RE: Schneider Tract MDP# 007-08

Re: **Schneider Tract**

MDP # 007-08

MASTER DEVELOPMENT PLAN
for
SCHNEIDER TRACT
#007-08

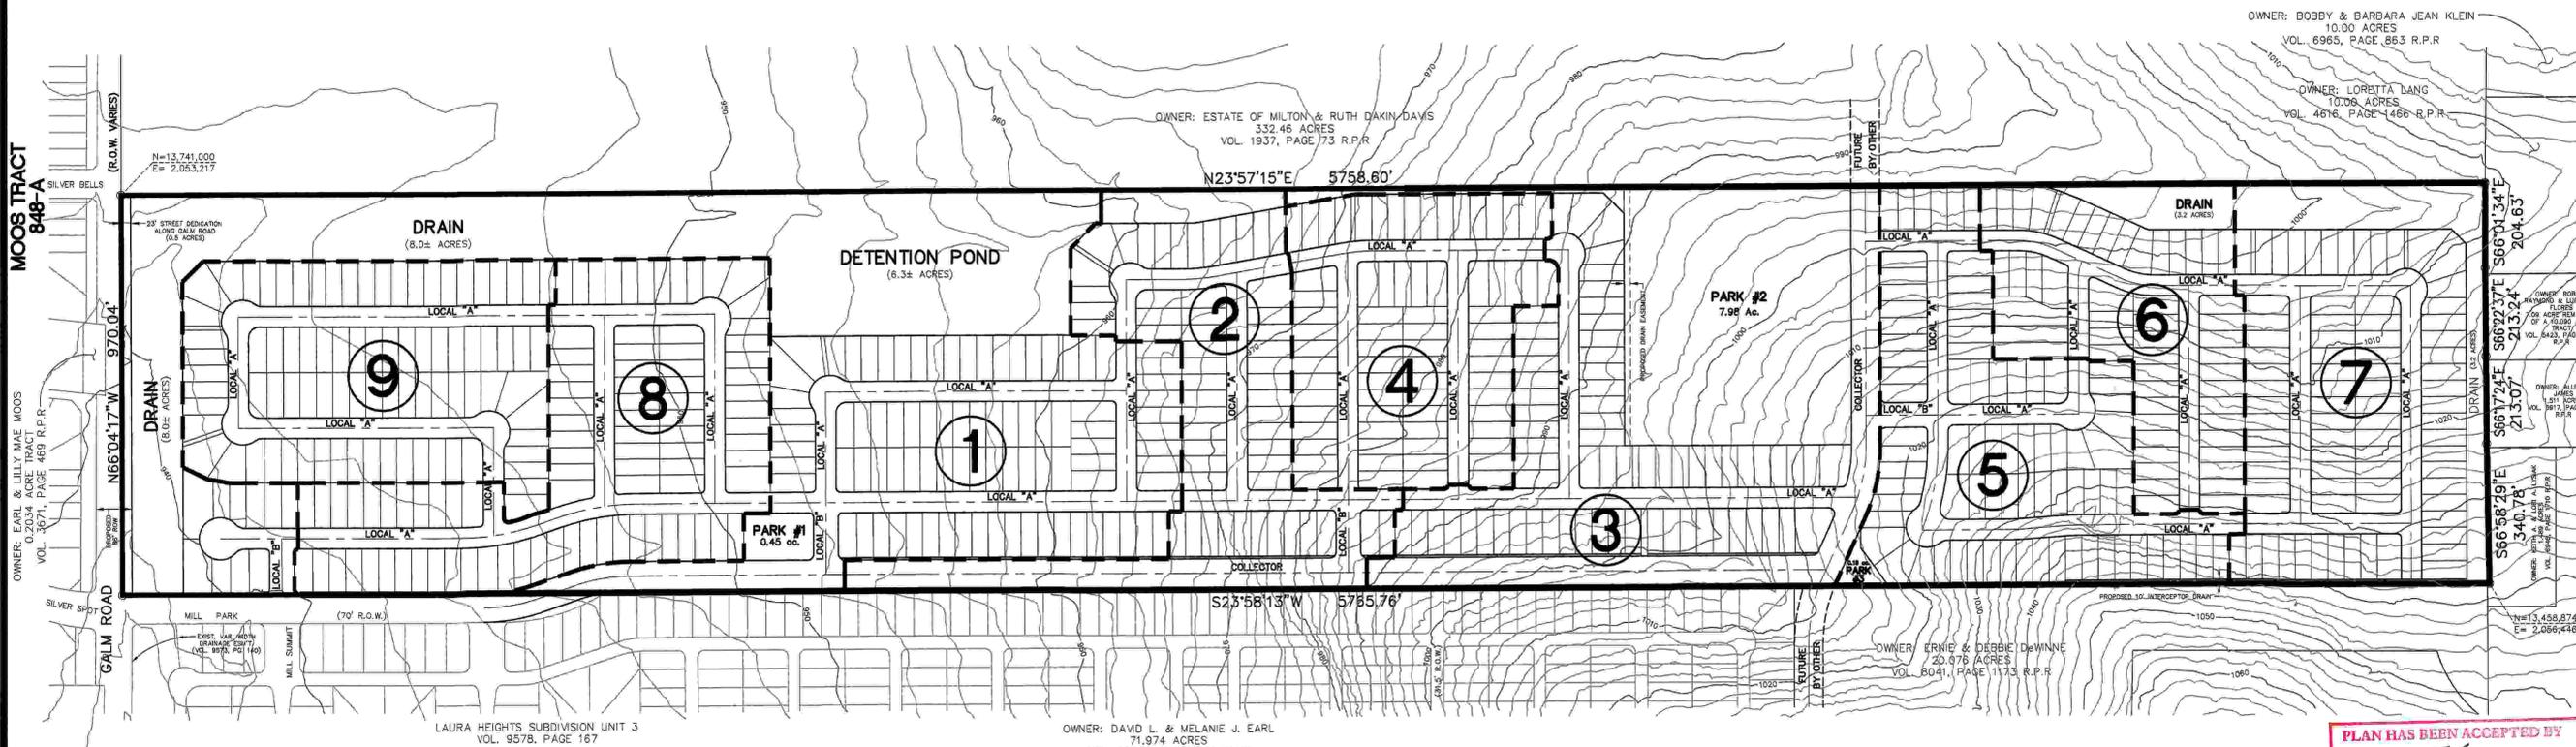
In consideration of public safety and convenience, excessive grades by reason of topography should be avoided in street layouts and arrangements. Any access and R.O.W. issues along state facilities will need to be resolved with the **Texas Department of Transportation (TXDOT)**. For information about these requirements you can contact TXDOT at (210) 615-5814.

- A Master Tree Permit (AP 1431820) has been approved for this project. Any changes to the approved plan require a new submittal of plan and a \$75.00 review fee.
- A \$75.00 review fee is required for each plat submittal stage and a Tree Canopy fee (\$15/lot) is required prior to recordation of each plat.

- Traffic controls shall be placed according to the standards of the Texas Manual on Uniform Traffic Control Devices.
- Coordination of design/construction for turn lanes on Galm Road with Bexar County Public Works Capital Project if applicable.

All platting shall comply with the Unified Development Code (UDC), Master Plan, Major Thoroughfare Plan, and all applicable regulations of the City of San Antonio. It will be expected that all of the property depicted in your Master Development Plan to include floodplains, drainage areas, and open space shall be platted. It is suggested to work closely with the school district, so they can plan accordingly.
